AMENDMENTS TO THE DRAWINGS

Attached hereto are five (5) sheets of corrected formal drawings that comply with the provisions of 37 C.F.R. § 1.84. The corrected formal drawings incorporate the following drawing changes:

FIG. 4 (PRIOR ART)

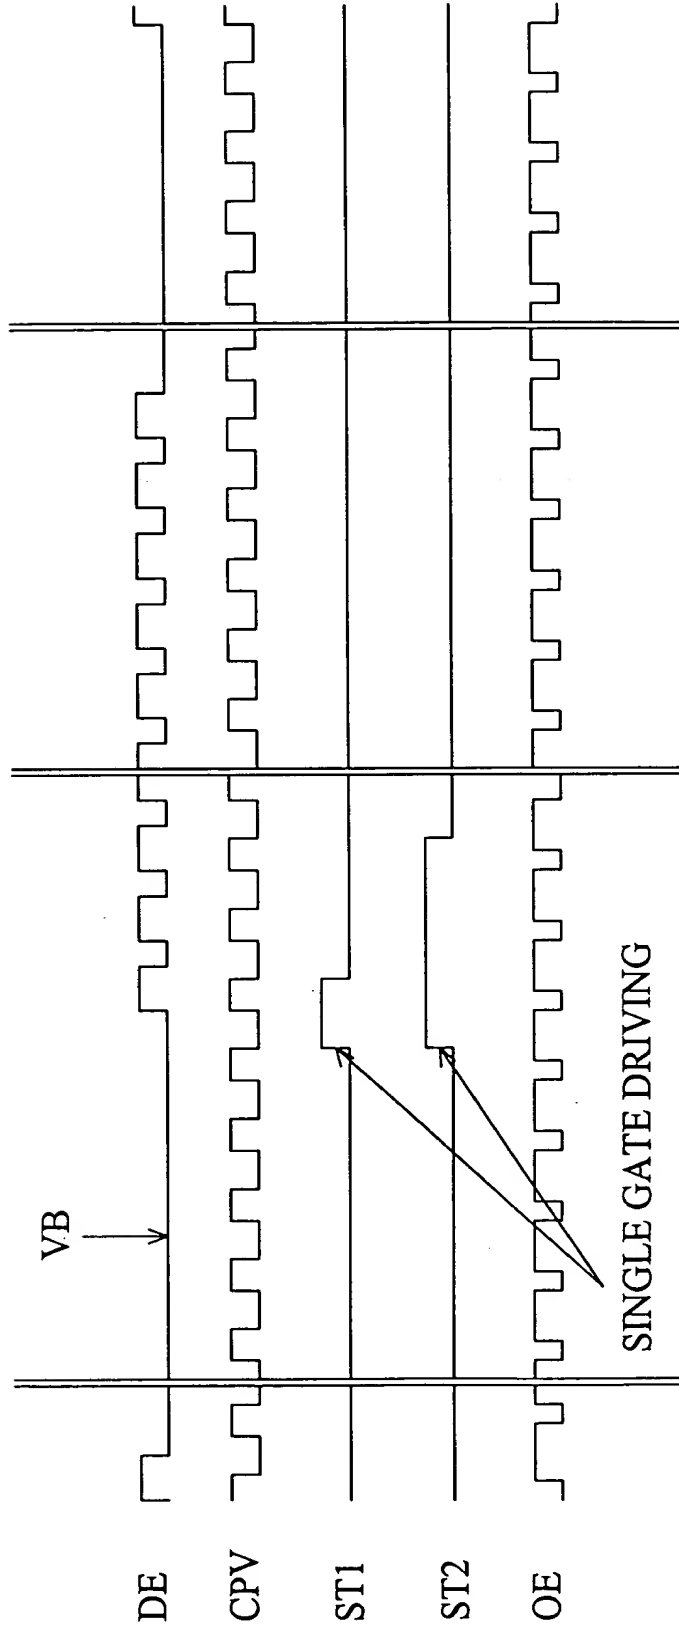
In Figs. 4-8, the legend "VB" has been added, and Figs. 5 and 6 have been amended to correspond to the description on page 2, lines 15-17, wherein "the gate clock signal CPV does not generate the start vertical signals STV1 and STV2 until after the vertical blank period VB (v-blank) of the data enable signal DE..."
